DANIEL O'WRIL, P.E.

November 18, 2011

RE: 93 Westland Avenue Renovation project

SK-2
2 OF 5

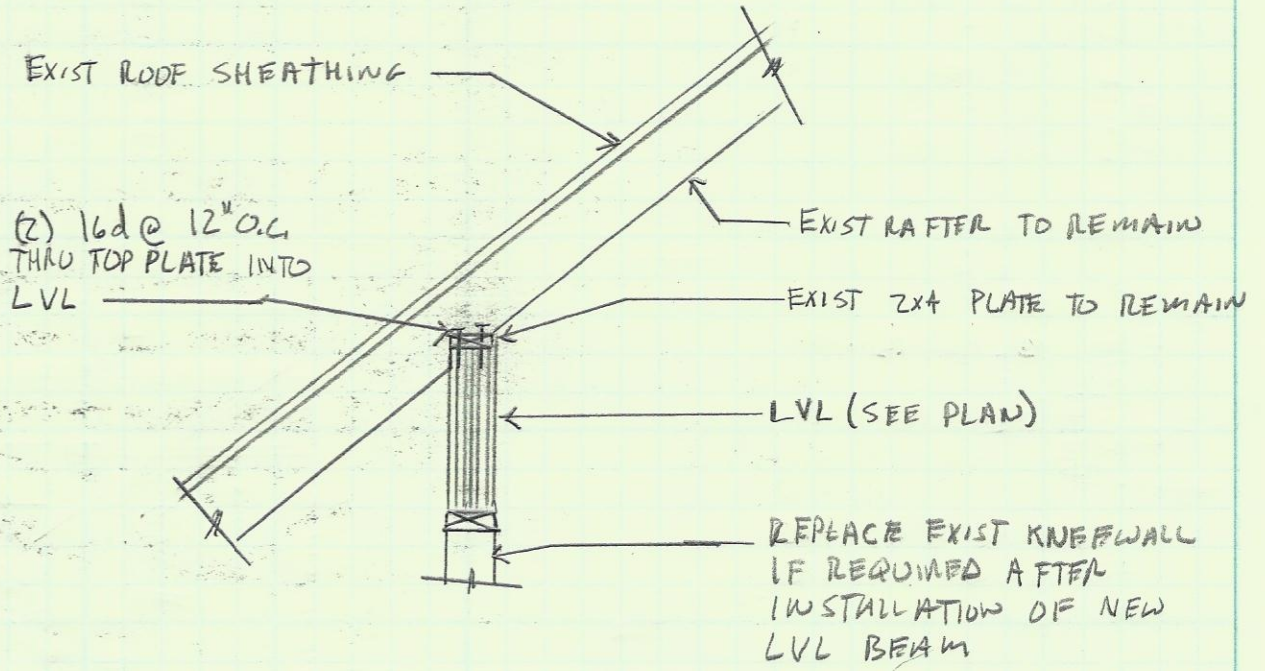
The second issue I reviewed was the roof rafters on the North side of the building. The original roof was reportedly lifted at the ridgeline to allow for more living space on the second floor. The rafters currently bear on the exterior wall at one end, a new knee wall at center span, and a new ridge beam at the other end. The new knee wall at center span is supported by the second floor framing. New rafters were sistered alongside the existing rafters to span from the knee wall to the center ridgeline. Upon review of this framing for code compliance, I found that the floor below the knee wall lacked the structural capacity to carry the roof loads from above. I recommend removing the existing knee wall and installing two LVL beams to remove the roof load from the existing floor framing. Details of this recommended repair are shown on the attached sketches.
